SUBJECT: IDENTIFICATION AND CONVERSION OF FLASHWRITER II BOARD UNITS AFFECTED: ALL SYSTEMS	MODEL: V3	V3-0026
	DATE: 8 DEC. 1981	PAGE: 1 OF 1

<b>SUBJECT:</b> <b>FWII REV.7</b>	<b>MODEL FWII</b>	<b>VIA# V3-014</b>
	<b>DATE 4/22/81</b>	<b>PAGE 1 of 5</b>

CONVERSION OF FLASHWRITER II	FLASHWRITER II	VTA# V3-0028
	FEB. 20 1980	PAGE 1 OF 2

# PRODUCT IMPROVEMENT BULLETIN

*U30-8 to U30-7*

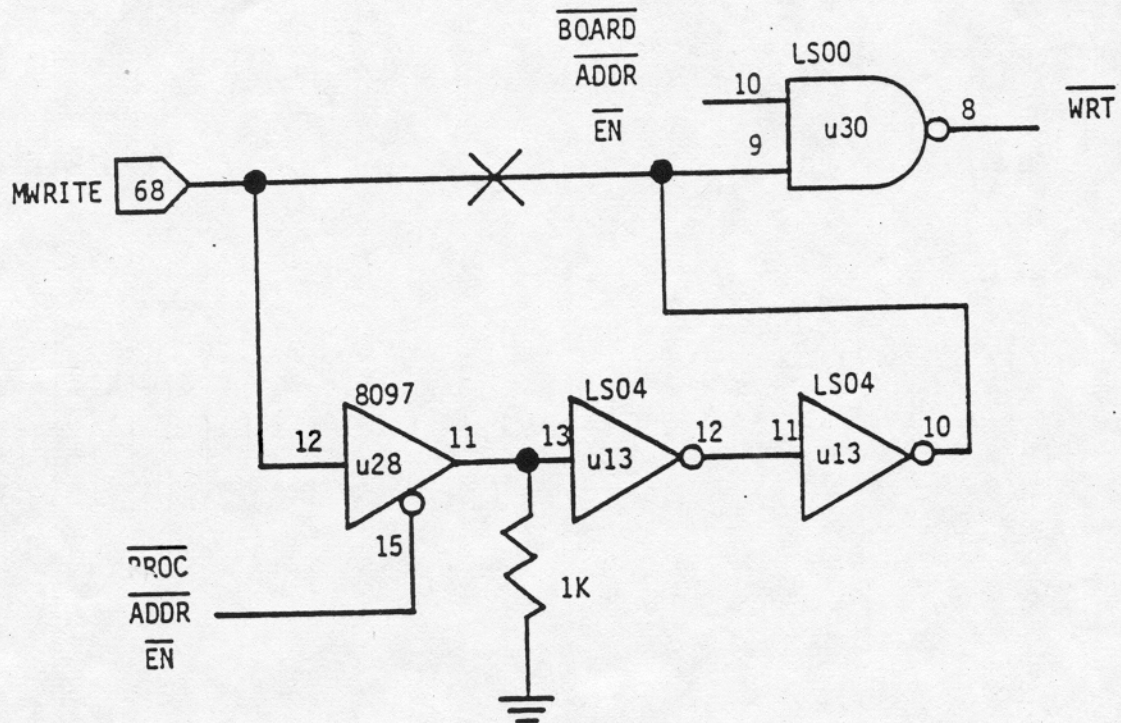
The addition of the 100 pf capacitor, C31, which created Rev 6 of the FW II PCB, did not sufficiently, compensate for the difference in various 2114 Ram manufacturer's specifications that impact timing and race conditions. Vector now recommends removing the 100 pf capacitor and implementing the following procedures:

Component Side:

1. Cut the trace between U29 and U30, which passes between pins U30-6 & 7, and U 29-10 & 11.
2. Add a 1K resistor between U13-13 and U14-7. Solder the resistor directly to the I.C. pins. The top lead of the resistor should not touch the lower lead of C6.

Circuit Side:

1. Install a jumper between U30-9 and U13-10.
2. Install a jumper between U13-11 and U13-12.
3. Install a jumper between U13-13 and U28-11.
4. Install a jumper between U28-12 and the feed-through hole just to the right of U29-10. (*Under U29*)

This will be revision 7 of the Flashwriter II PCBA.

CIRCUIT SIDE

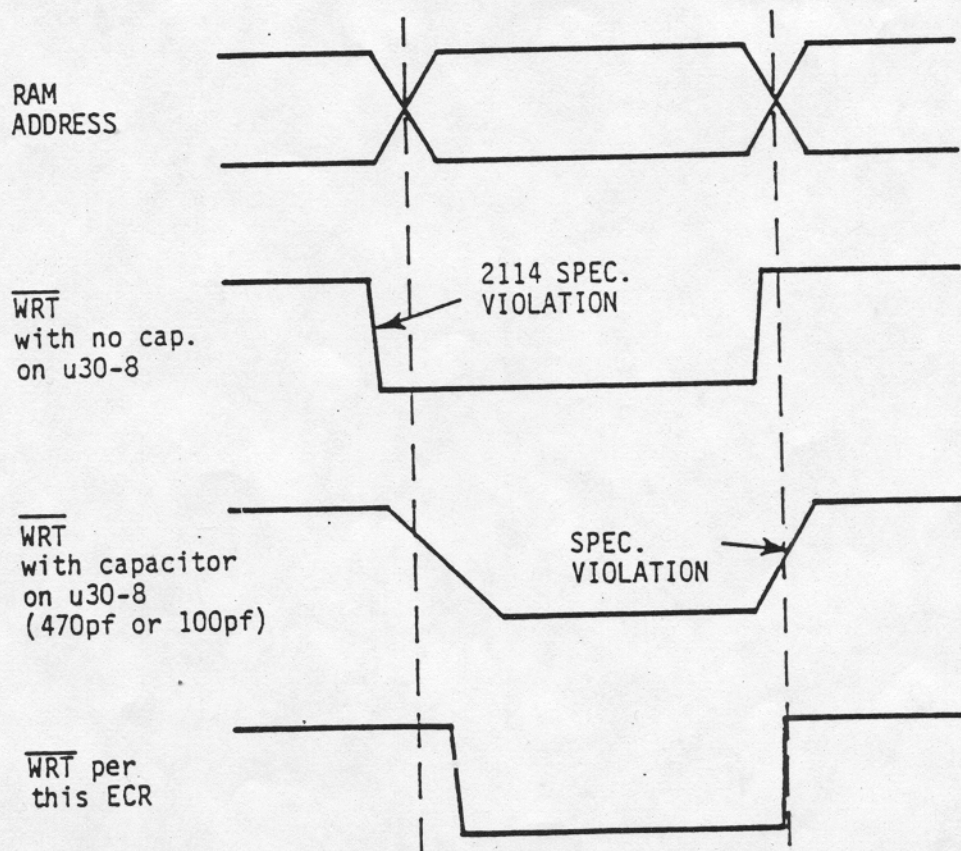
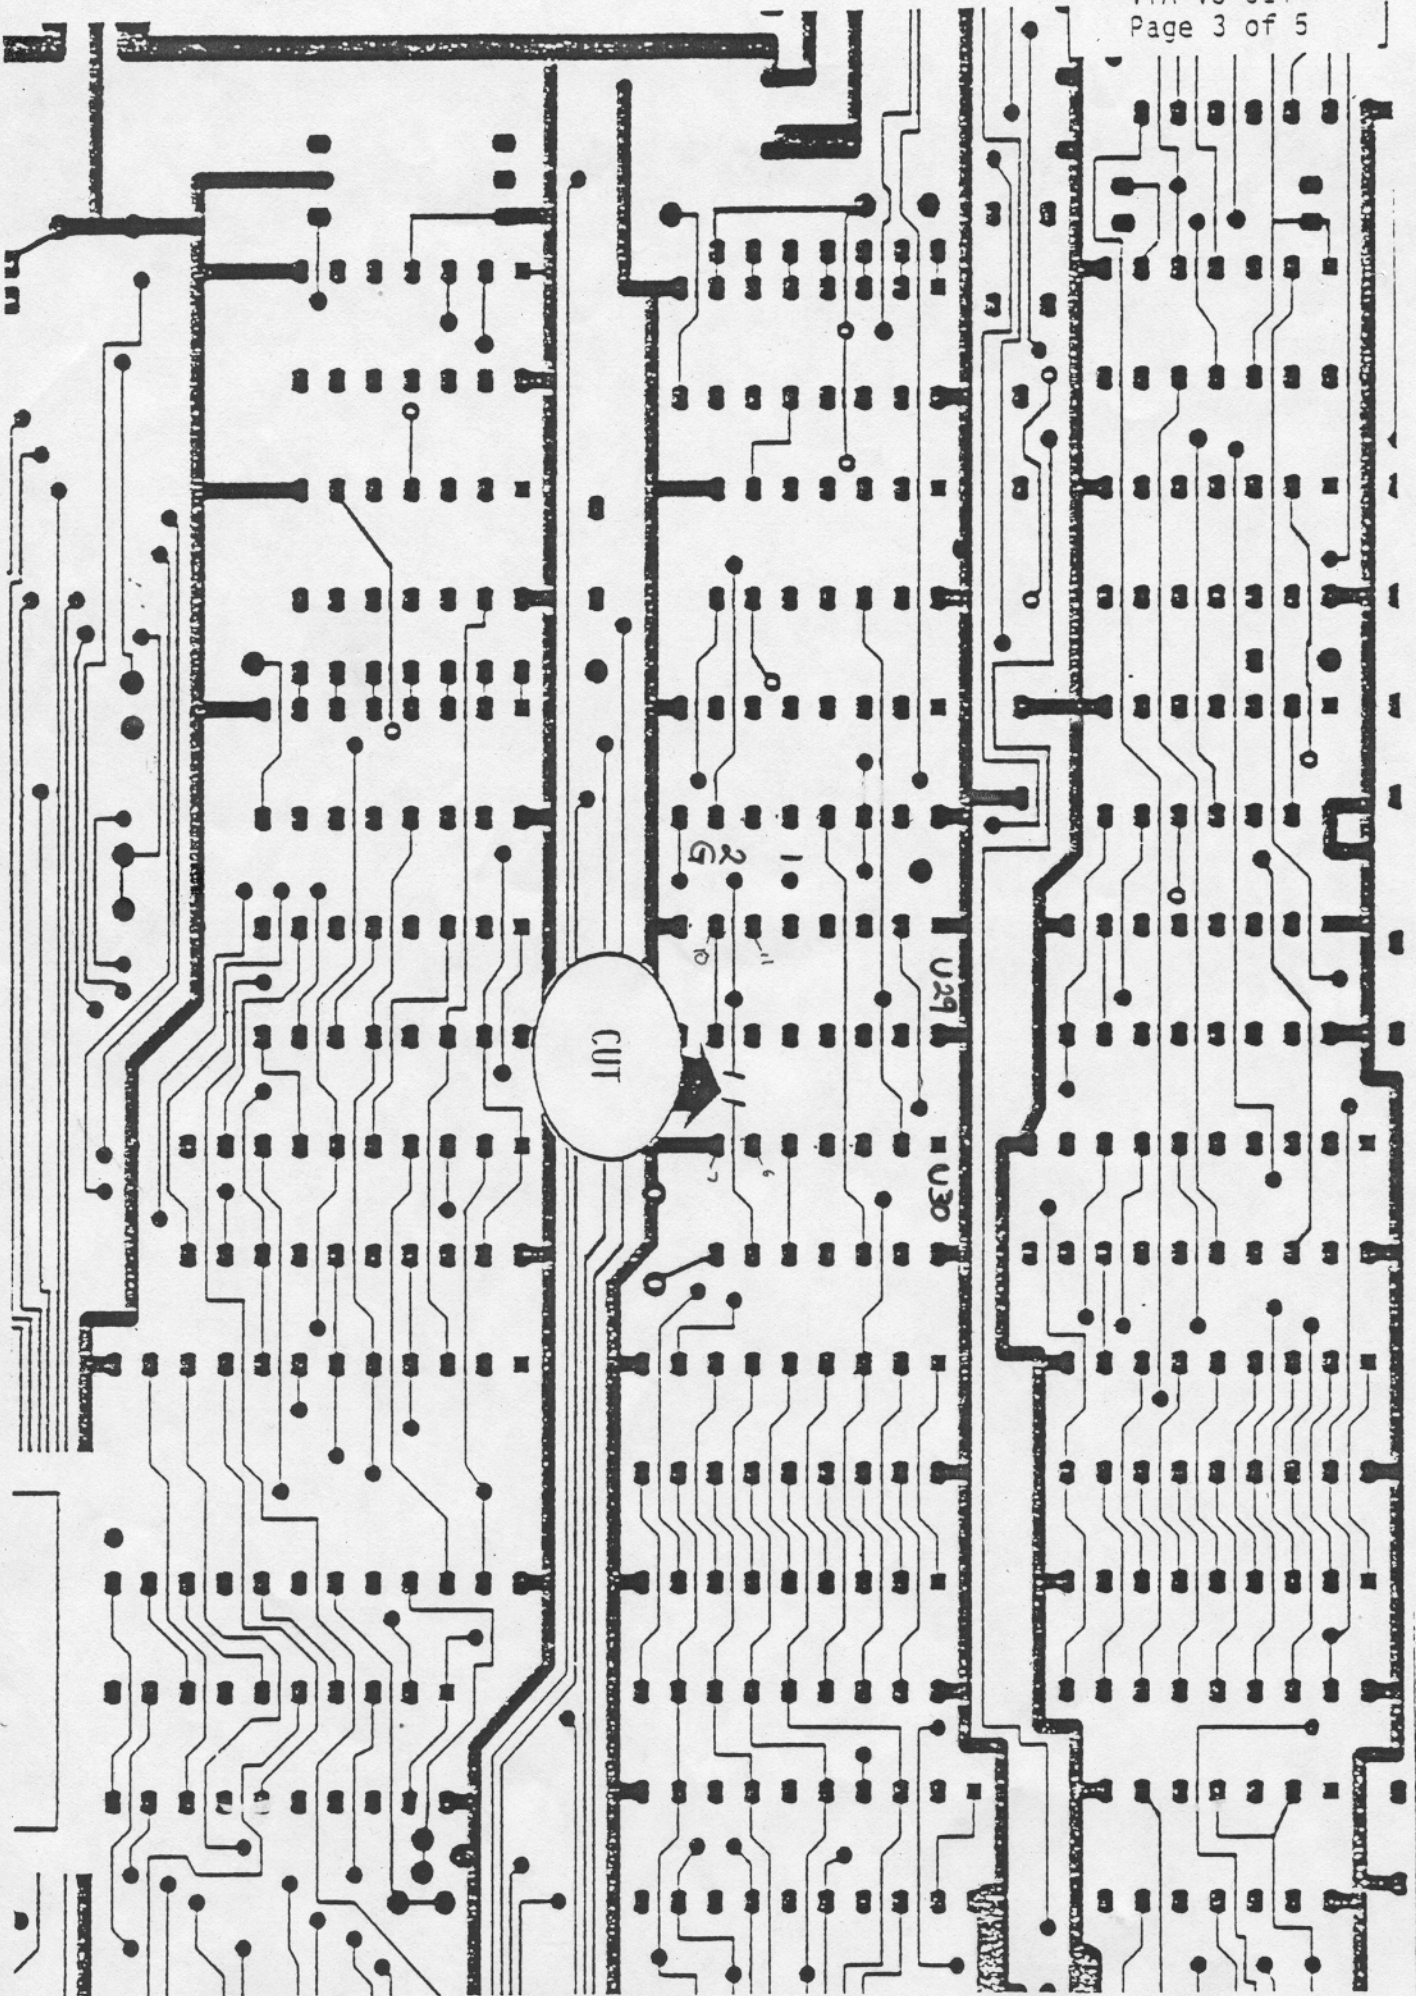
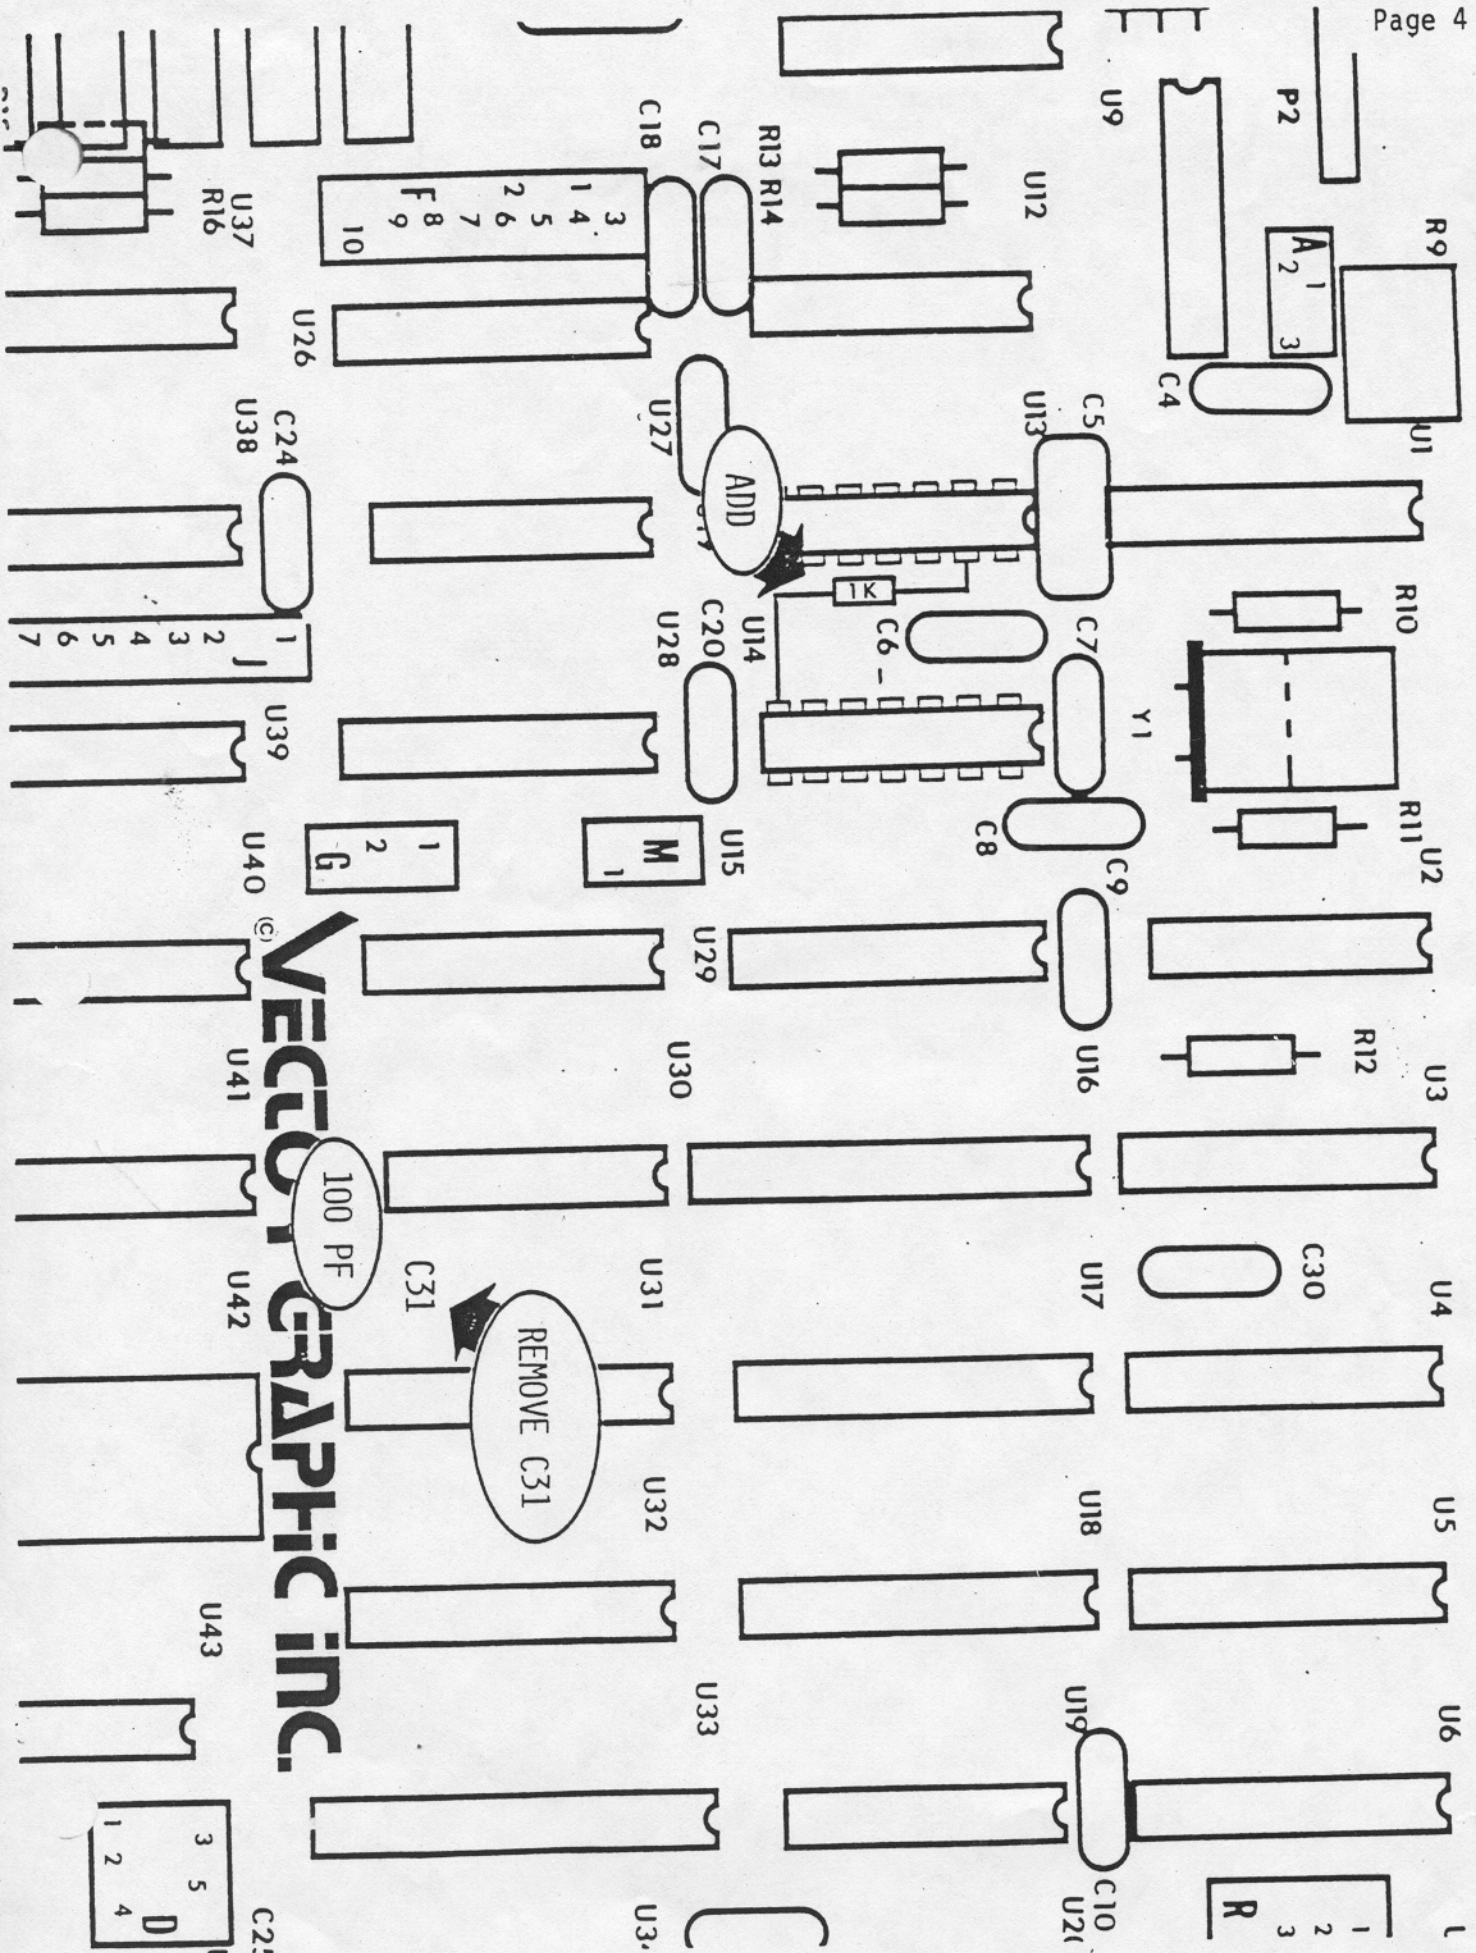
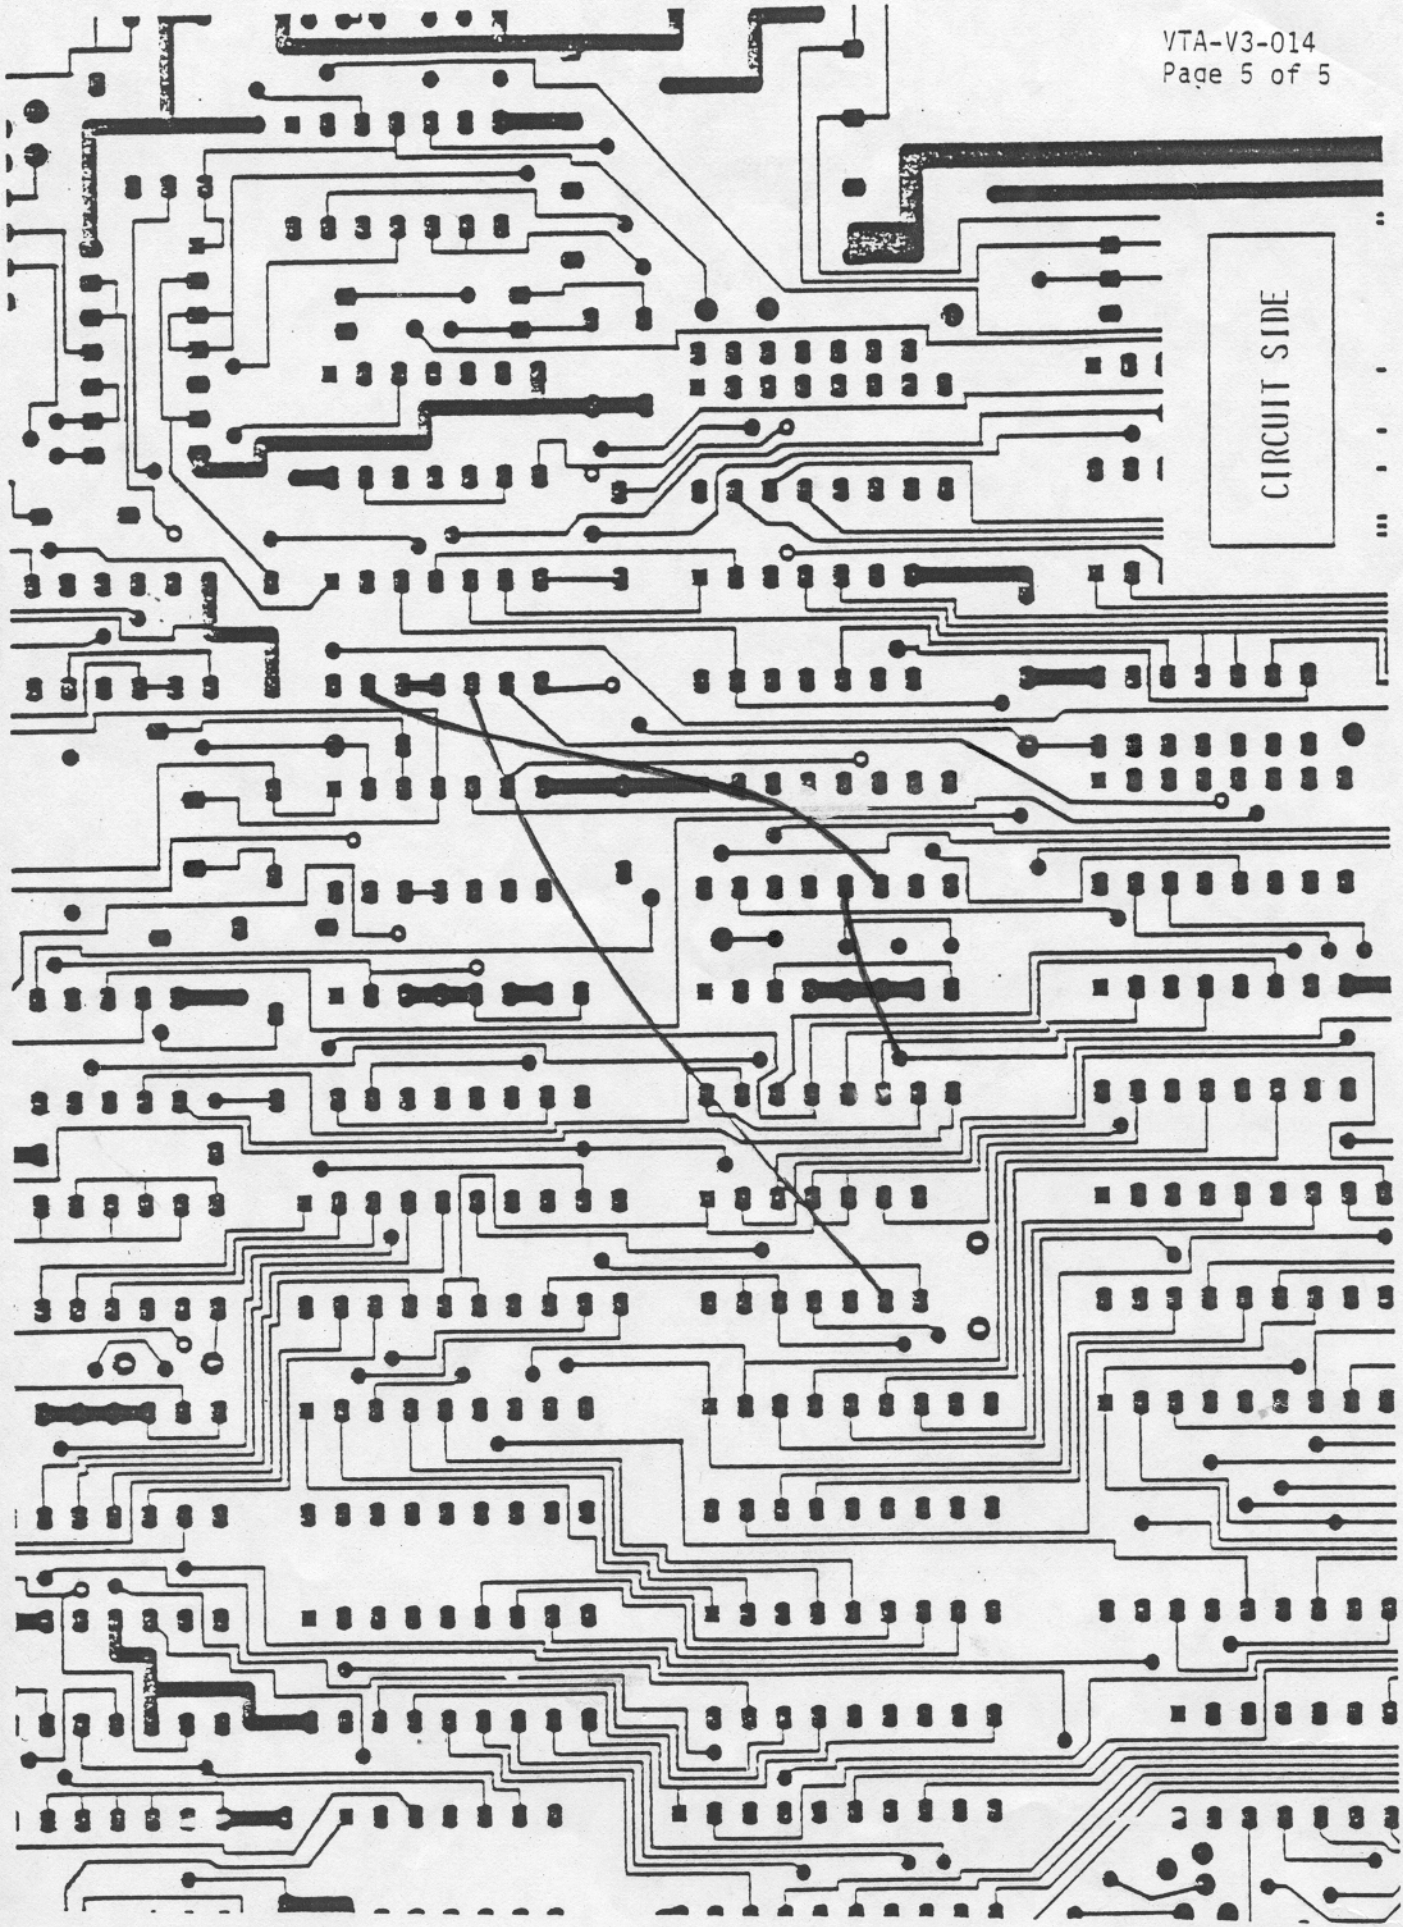
u28 IS USED TO EXPAND u30. (NO SPARE LS10 IS AVAILABLE ON THE BOARD.)

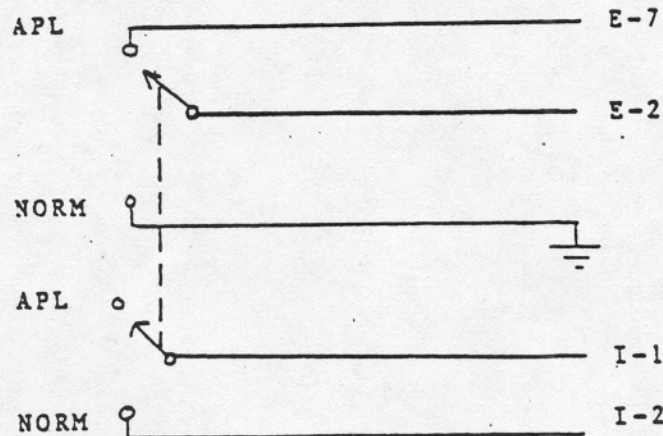
The following will explain the cuts and jumpers necessary to incorporate the APL Character Generator PROMs on the Flashwriter II Rev. 3.

I. For INTEL 2716 or TMS 2516 only--

A) Add switch as shown below

B) Cut etches Jumper from

I1-I2	B1-B3
E1-E4	E1-E5
E2-E5

C) Insert APL PROMs at U22 and U23

Use APL TMS 2516 or INTEL 2716 at U22  
Use APL 2708 at U23

FLASHWRITER II Rev.3 APL MODIFICATION

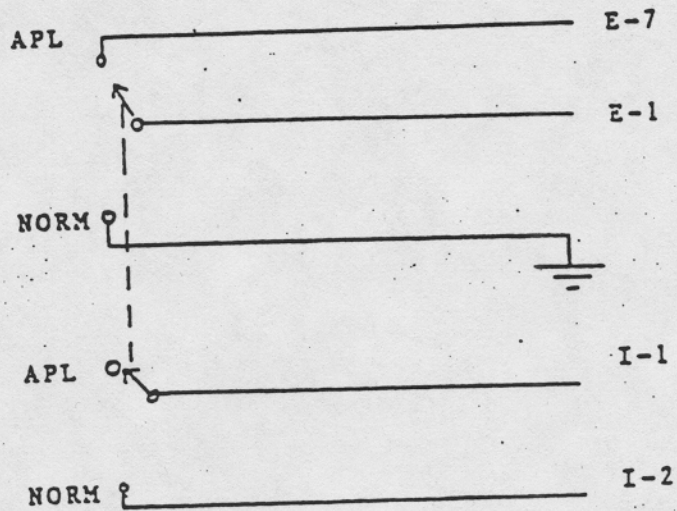
II. For TMS 2716 proms only -

A) Add switch as shown below

B) Cut Etches

- I1 to I2
- E1 to E4
- E2 to E5
- E3 to E9
- trace from U22-18

Jumper from

- B1 to B2
- E1 to E3
- E2 to E6
- E5 to U22-18

C) Insert APL PROMs at U22 and U23

- Use APL TMS 2716 at U22
- Use APL 2708 at U23
